Technical Bulletin

Date	Ref. No.	Model	FB
12.01.99	**TV10598R**	**KV-28FX60B, KV-28FX60D, KV-28FX60E, KV-28FX60U, KV-32FX60B, KV-32FX60D, KV-32FX60D4, KV-32FX60E, KV-32FX60K, KV-32FX60U**	
Subject **No Chroma on AV3 Input [REVISION]**			IRIS F411

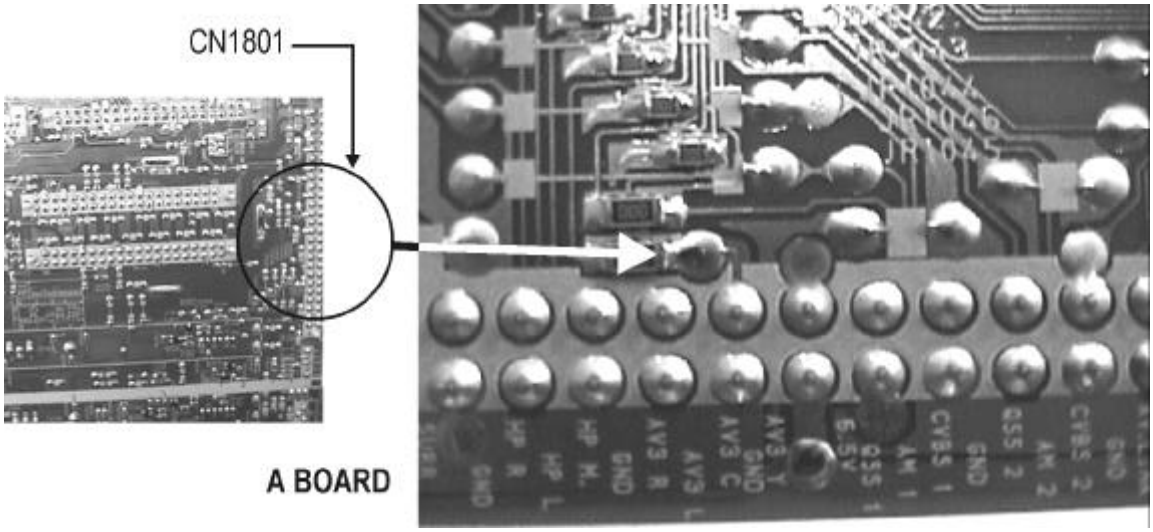
No chroma on the AV3 input.

JR1045 on the A Board is missing.

Mount JR1045 on the A Board.
